UNITED STATES PATENT AND TRADEMARK OFFICE

Office Action Summary

10/814,610

SCHAEFFER, DARIN G.

Attachment #1 (marked up)

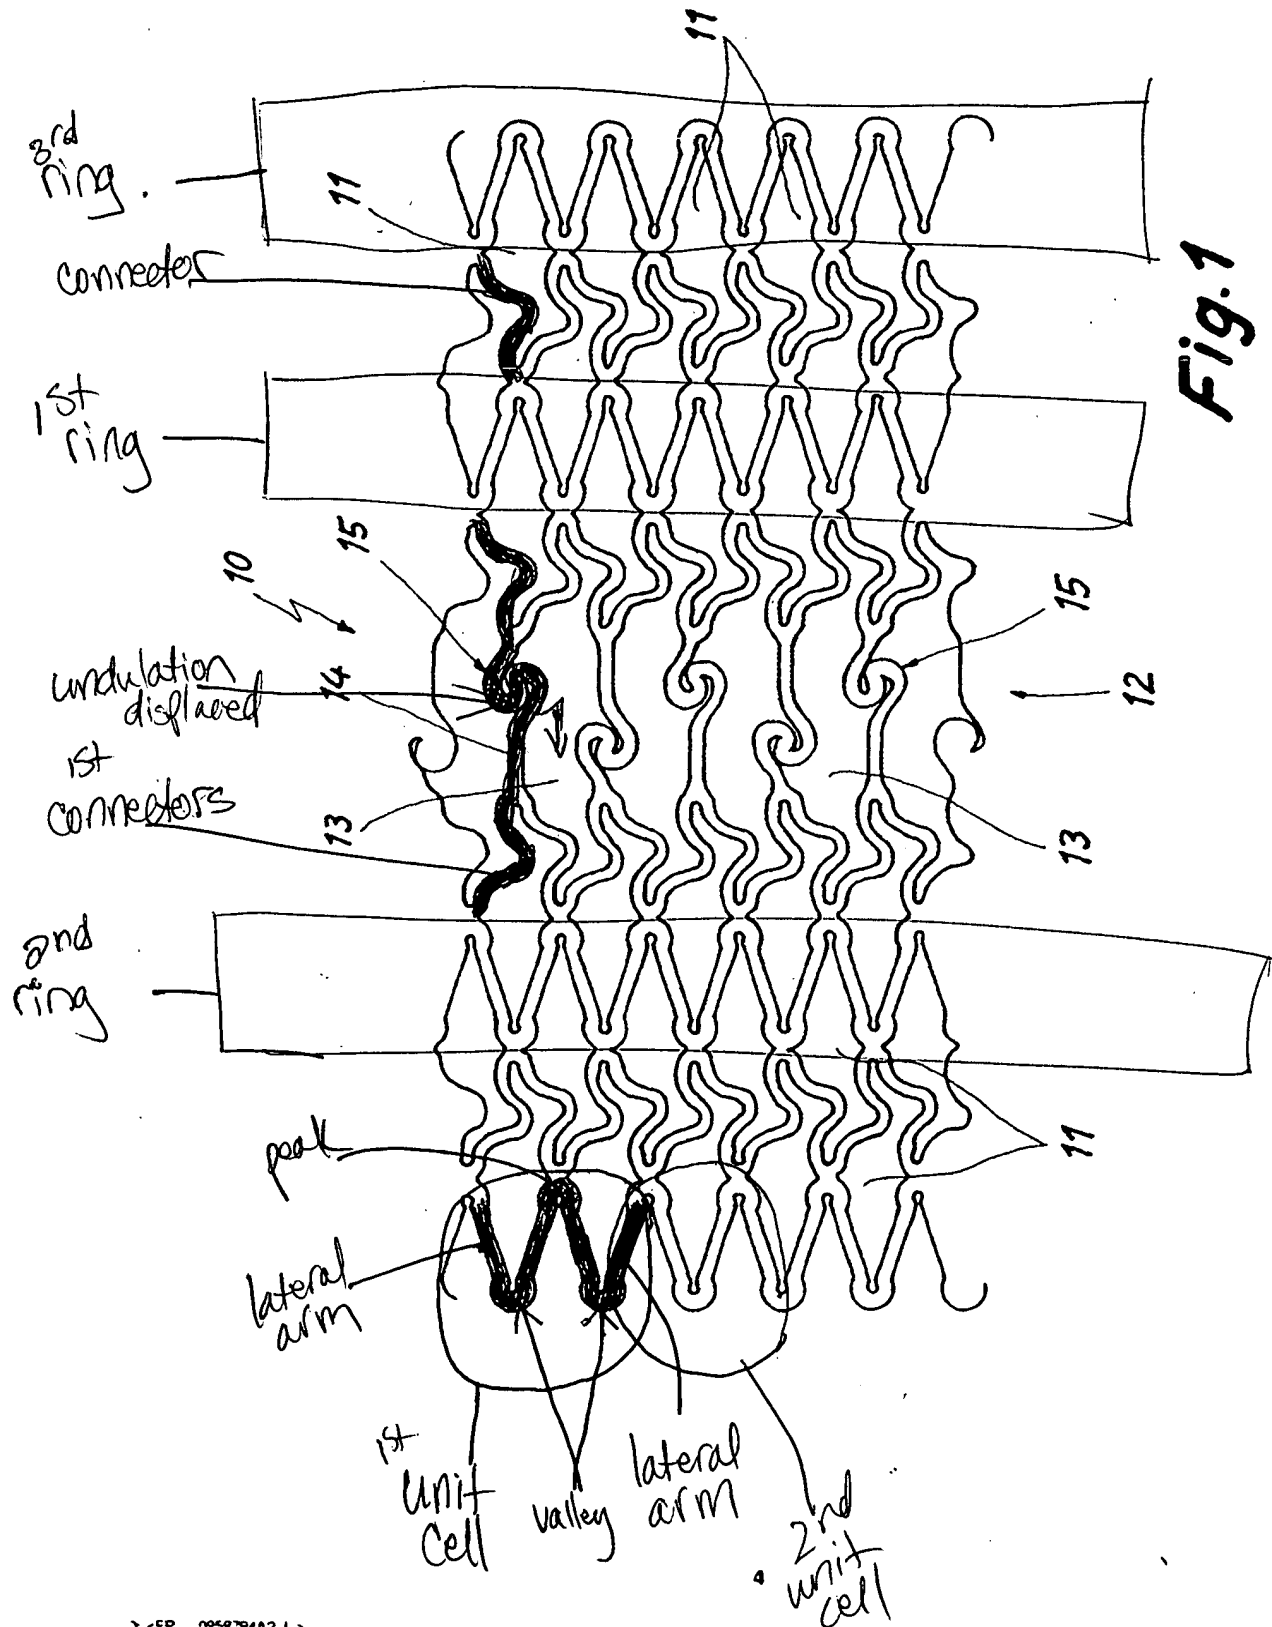
Claims 1-8 and 11-22 are rejected under 35 U.S.C. 102(b) as being anticipated by Schmitz et al. (EP 0 958 794 A2, cited in IDS). Referring to claims 1 and 17 groupings, Schmitz discloses a stent (10) having first, second, and third ring structures, a first plurality of connector segments joining the first and second ring structures and a second plurality of connector segments joining the first and third ring structures, wherein the undulation of the first connectors are axially displaced from one another and the undulation of the second connectors are axially aligned to one another. Schmitz discloses the ring structures to comprise units, each unit having two lateral arms and a central region having a peak and two valleys. Schmitz discloses the undulating connector to form u-shaped bends. Schmitz discloses pads having an enlarged and narrow throat region. See attachment 1, figure 1, where claimed structures are pointed out.

Attachment #2 (markedup)

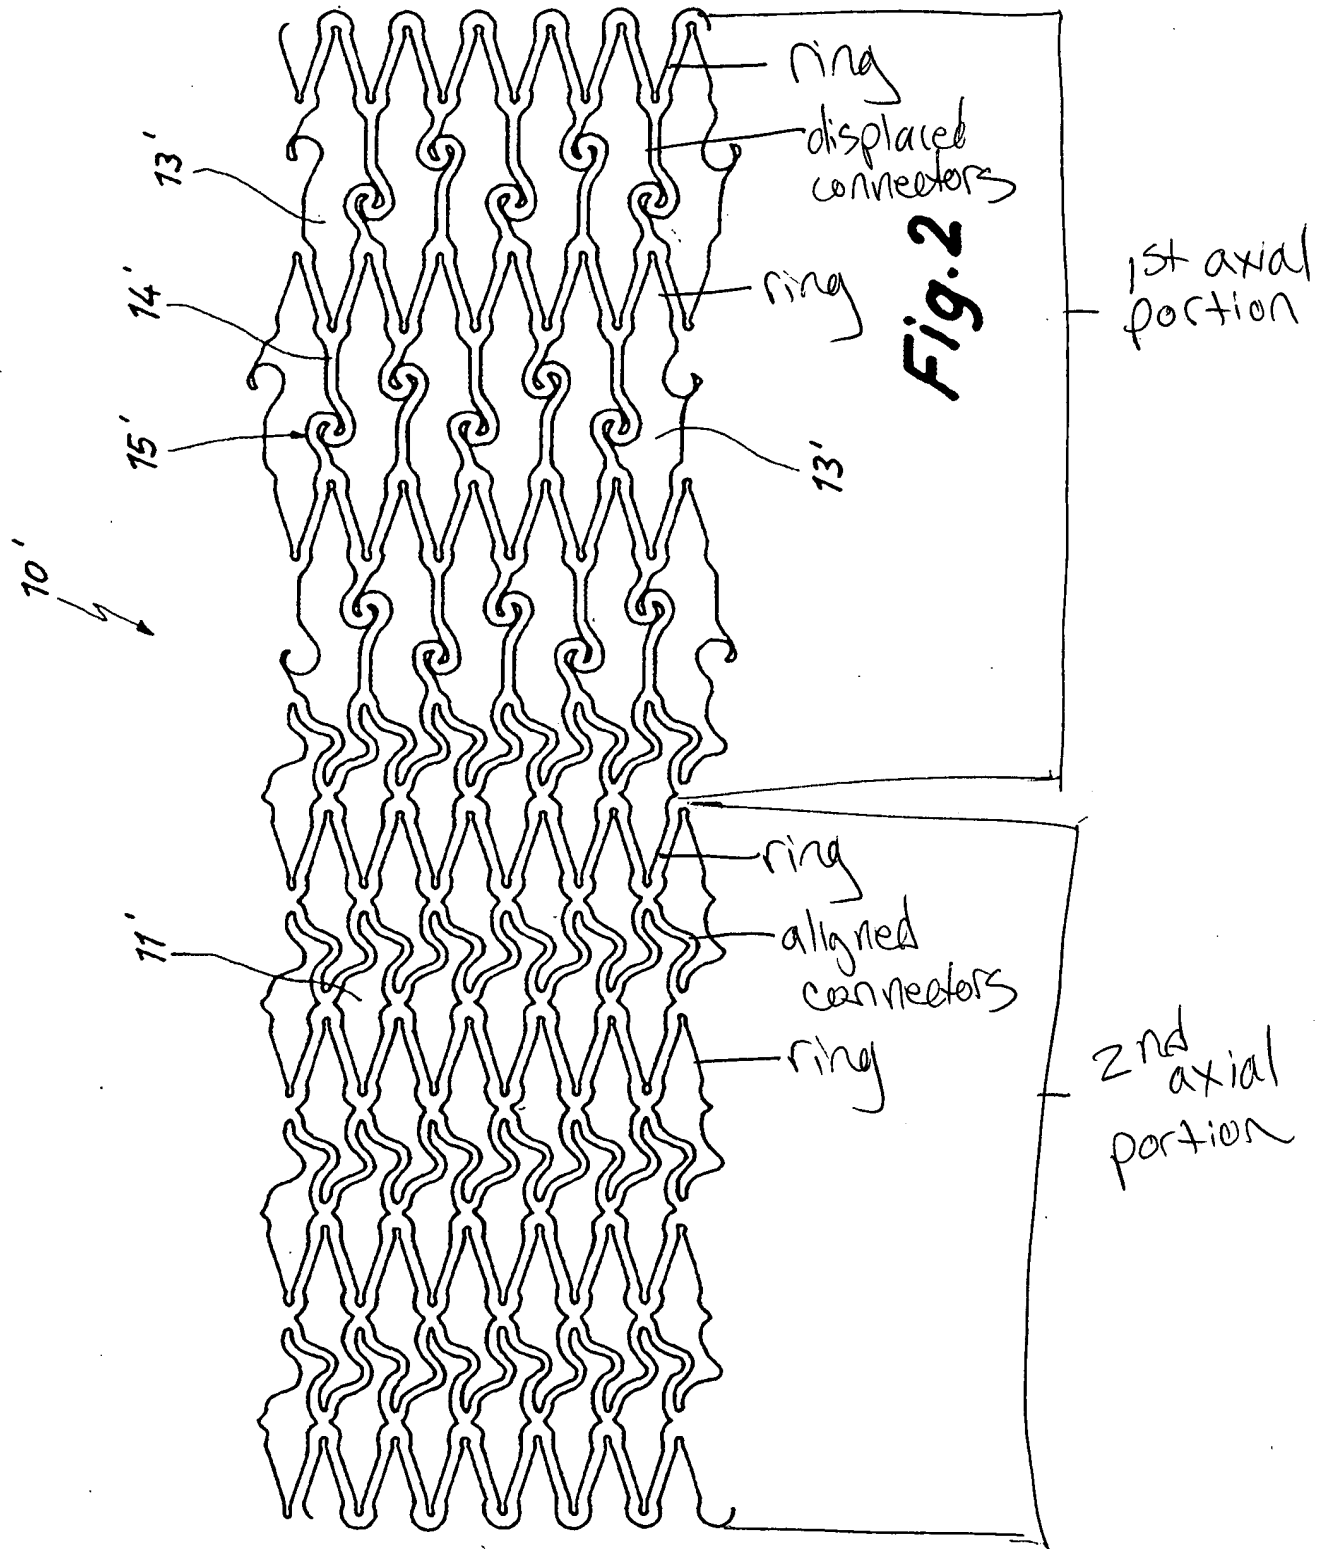
Referring to the claim 11 grouping, Schmitz discloses a stent comprising first and second axial portions, the first axial portion having a plurality of ring structures joined by axially displaced connectors and the second axial portion having another plurality of ring structures joined by axially aligned connectors. See figure 2, attachment 2.

Attachment #3 (marked up)

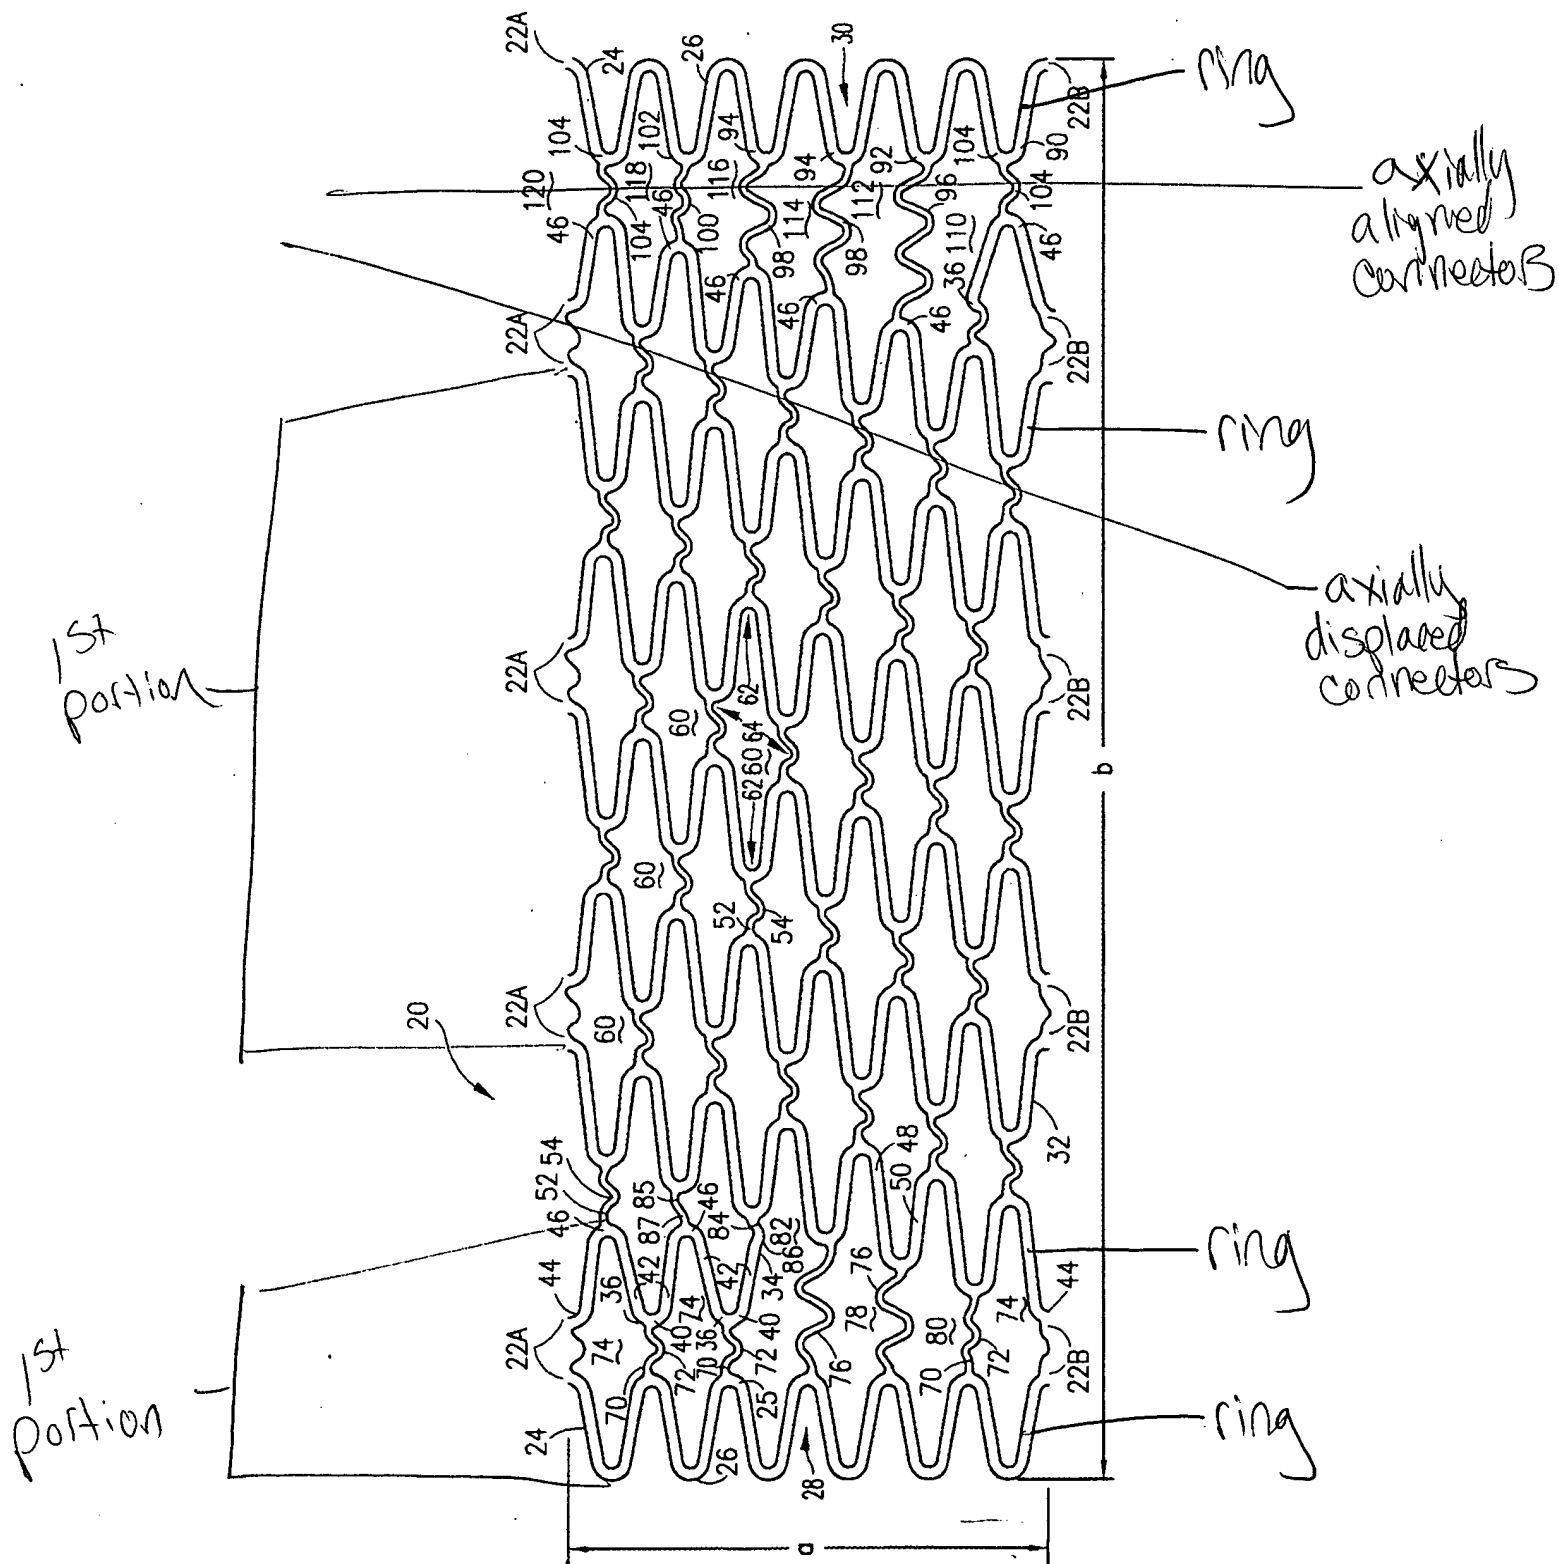
Claims 11-22 are rejected under 35 U.S.C. 102(e) as being anticipated by Levinson et al. (US 6,352,552 B1). Referring to the claim 17 grouping, Levinson discloses a stent having a plurality of ring structures (24, 32) joined by a plurality of connector segments (52, 70, 96, 98, 100), each of the connector segments having an undulating portion (bend 54, 76, 72, etc), wherein a first circumferential set of connector segments are axially aligned and a second circumferential set of connector segments are axially displaced. See attachment 3.

Referring to the claim 11 grouping, Levinson discloses a stent comprising first and second axial portions, the first axial portion having a plurality of ring structures joined by axially displaced connectors and the second axial portion having another plurality of ring structures joined by axially aligned connectors. See figure 1, attachment 3.
